Spokane Design Review Board

Wednesday, September 23, 2020

5:40 – 7:40	5) North West Middle School – Recommendation Meeting	Taylor Berberich
	• Staff Report..... 15-20 m	
	• Applicant Presentation..... 25 m	
	• Public Comments and Board Q & A 25 m	
	• Board Discussion and Motion(s)..... 45 m

Figure 3- Wellesley Frontage

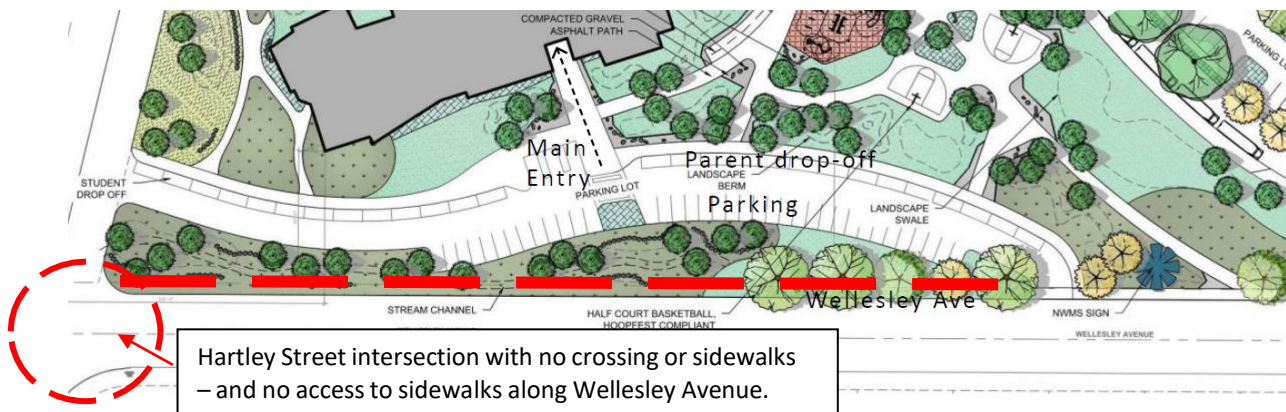
1. The site plan proposes a sidewalk on Wellesley Avenue from the southeastern corner of the subject site to the eastern edge of the drive aisle for the student drop-off along Wellesley Avenue, but the sidewalk does not fully extend to the southwest corner of the site (to connect with the existing sidewalk west of the subject site- the Ball & Dodd property). Does the Board have any recommendations for the Action Approving Authority regarding pedestrian connectivity along the Wellesley Avenue frontage? It should also be noted that the sidewalks along both sides of Hartley Street (which intersects Wellesley Avenue nearest the western circulation road curb-cut) have no pedestrian connectivity to the school site. Presumably, student's walking to the Middle School from the south along Hartley would need to enter Wellesley at an unregulated intersection, then walk through the landscaping to access the school sidewalks. The dashed red line in the image below (see Figure 1) indicates the portion of the Wellesley Avenue frontage with no proposed sidewalk specified.

Applicant response to staff comments: We agree that a short connecting sidewalk should be added at the east end of the interior east/west sidewalk. An ADA ramp and link will be provided between the Wellesley/Hartley intersection and the sidewalk on the north side of the parent drop off. See the previous response regarding issues created by adding a sidewalk along the Wellesley Street edge.

Figure 4- Western side of school

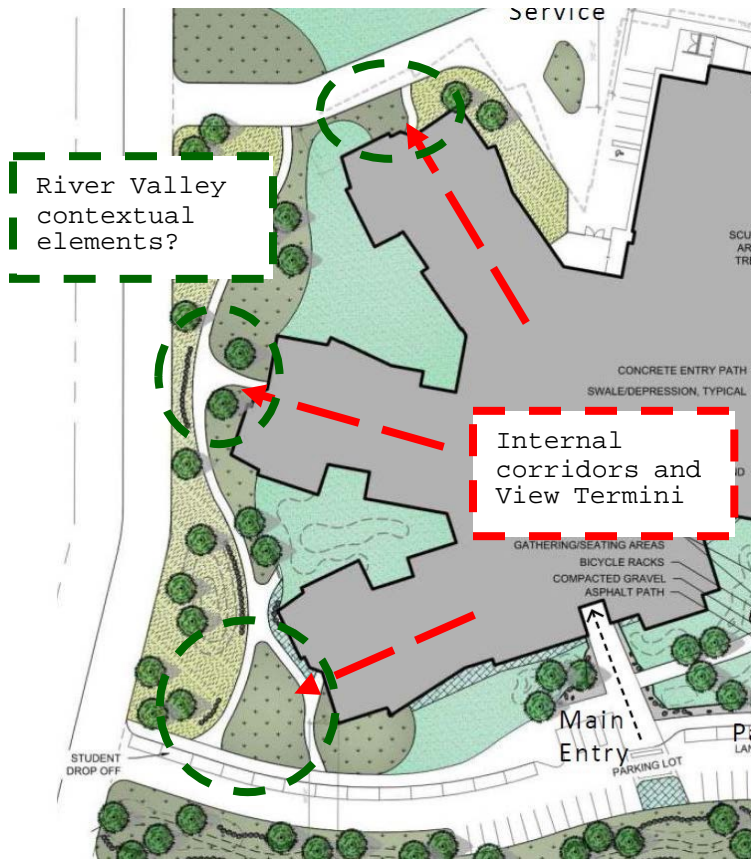
3. What recommendation can the Board provide regarding the site design, and how the organizational parti of the building (the Base, the Field, the Western Ridge) or the river valley's observed main qualities (Natural Spaces, Natural Intersections, Natural Textures) inform/influence the Middle School's site layout? Significant effort was expended capturing the contextual elements of the river valley and how the micro-canyons of basalt, water flow, and living systems combine to create a punctuated series of compressions and expansions. Can this experiential phenomena be replayed in the landscape design to capture or frame the views offered by the windows terminating the academic villages' circulation corridors?

Additional Staff Comments: it is not staff's intent to imply that the design review process could dictate interior views. The additional staff Topic for Discussion was offered to note that the western landscape design of the site does not meet the architect's "layered" parti. Staff offered the graphic (Figure 4) to indicate one potential solution to more fully integrate the architectural design and the landscape design (consistent with the high level of integration found along the south and east sides of the site).

Applicant response: We appreciate the comments, but we question DRB's purview over views from the interior of the building. We have no additional response or comment.

Figure 5- Western Circulation

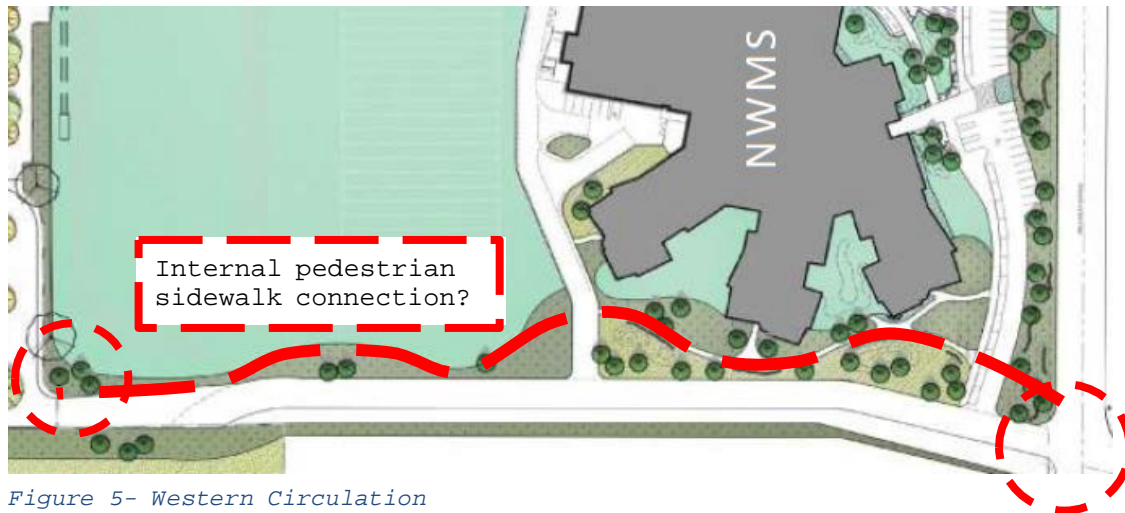
4. Regarding the western circulation road, if this roadway is intended to be constructed as one-half of an eventual public access route to a future residential development to the northwest of the school site is there a reason to construct a sidewalk along the improved one-half street (to comply with the street design standards, applicable to both public and private streets)? For this project and the stadium, this sidewalk (or Share-Use Path) would serve a similar purpose to the separated Shared-Use Path leading to the Albi Stadium site along the eastern circulation road – and it would provide pedestrian connections from Wellesley & Hartley to the school building, the Middle School's playfields, and a connection to the currently proposed pedestrian sidewalk along the western circulation road on the Albi Stadium site.

Applicant response: SPS does not want to encourage pedestrian traffic along the west side of the site, this is the service side of the school. Doors and sidewalks exiting the building to the right-of-way, (Wellesley), are strictly for student egress. The courtyard spaces between the classroom wings will be landscaped for educational use only. The internal sidewalk separated from the access/service road is provided for this purpose. The west access road is part of an easement to accommodate a future street that would serve a potential future development to the north, there is no way to know when that development might happen. If the development to the north does occur in the future, full development of the street, including sidewalks meeting future design standards, will then be required.

Figure 6- Pedestrian connections to main entry

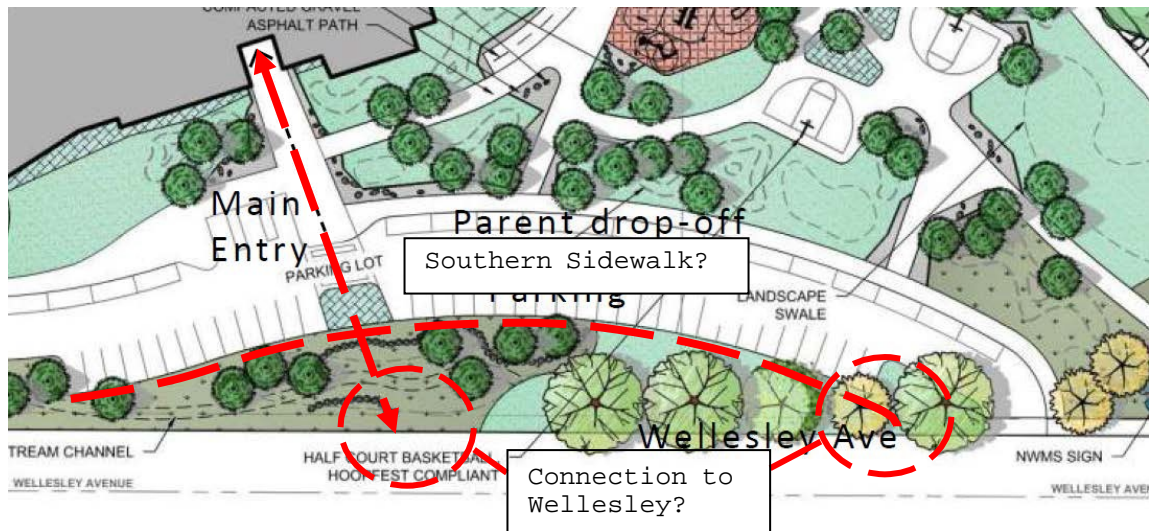
6. It appears that the Applicant is proposing an “in-boarding” of the Wellesley Avenue northside sidewalk by migrating it onto the site to serve as a frontage sidewalk for the student drop-off and visitor parking lot. Whether or not this configuration continues, the 90-degree parking stalls along the south side of the one-way drive aisle have no sidewalk on which to load – though there is a narrowed pedestrian crossing of the drive aisle (on alignment with the building’s Main Entry sidewalk); which, without a southern sidewalk appears to serve no purpose. If no Wellesley Avenue sidewalk is constructed, shouldn’t a sidewalk serving the south 90-degree parking stalls be provided? If a Wellesley Avenue sidewalk is constructed, shouldn’t the sidewalk from the Main Entry (crossing the student-drop off/visitor parking lot) be extended to the new sidewalk along Wellesley?
